UNITED STATES
NUCLEAR REGULATORY COMMISSION
WASHINGTON, D. C. 20555

The Commission has issued the enclosed Amendment No. 84 to Facility Operating License No. DPR-32 and Amendment No. 85 to Facility Operating License No. DPR-37 for the Surry Power Station, Unit Nos. 1 and 2, respectively. The amendments consist of changes to the Technical Specifications in response to your application transmitted by letter dated September 23, 1982, as supplemented January 17, 1983.

These amendments revise the Technical Specifications to remove a restriction on moving a spent fuel cask into the Fuel Building. Requirements are added to install cask impact pads in the spent fuel pool and to not store spent fuel decayed less than 150 days in the first three rows of fuel racks adjacent to the Fuel Building Trolley Load Block.

SAFETY EVALUATION BY THE OFFICE OF NUCLEAR REACTOR REGULATION

FIGURE 5.4-1

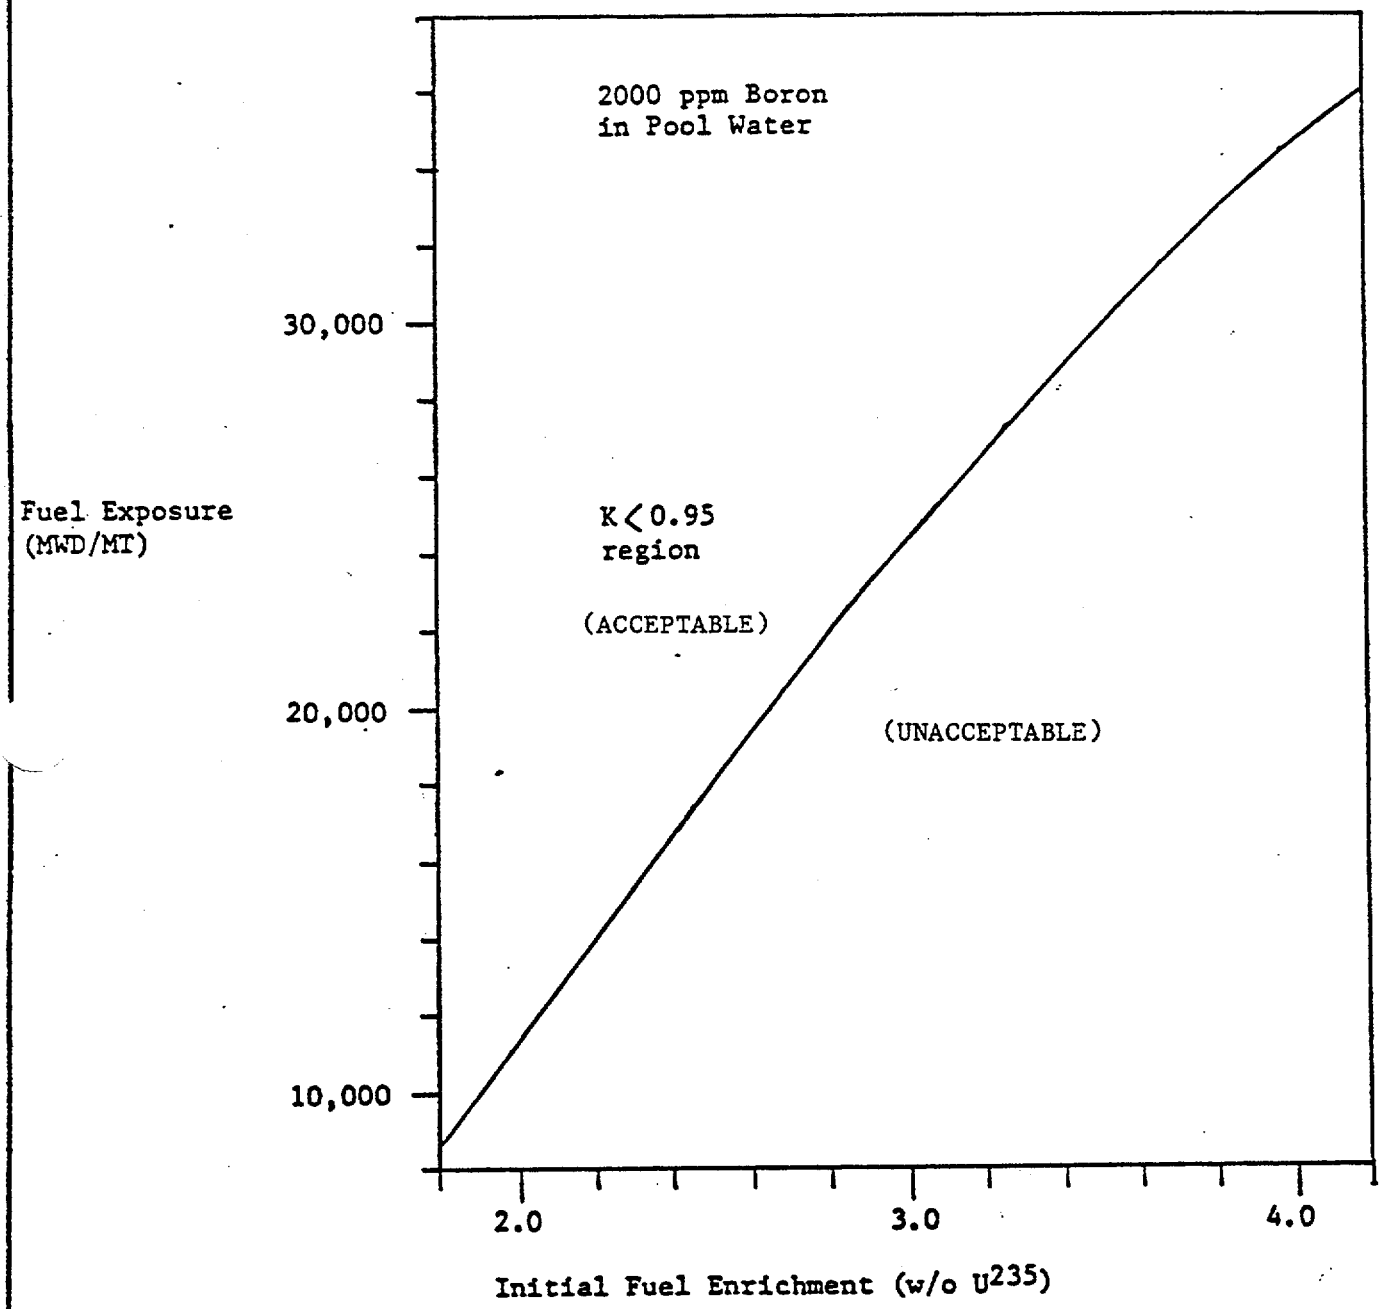
Remove Pages	Insert Pages
3.10-4	3.10-4
5.4-2	5.4-2
-----	Figure 5.4-1

assemblies to assure k_{eff} 0.95, even if unborated water were used to fill the spent fuel storage pit. The spent fuel pool is divided into a two-region storage pool. Region 1 comprises the first three rows of fuel racks (324 storage locations) adjacent to the Fuel Building Trolley Load Block. Region 2 comprises the remainder of the fuel racks in the fuel pool. During spent fuel cask handling, Region 1 is limited to storage of spent fuel assemblies which have decayed at least 150 days after discharge and shall be restricted to those assemblies in the "acceptable" domain of Figure 5.4-1. Administrative controls with written procedures will be employed in the selection and placement of these assemblies. The enrichment of the fuel stored in the spent fuel racks shall not exceed 4.1% weight percent of U-235.
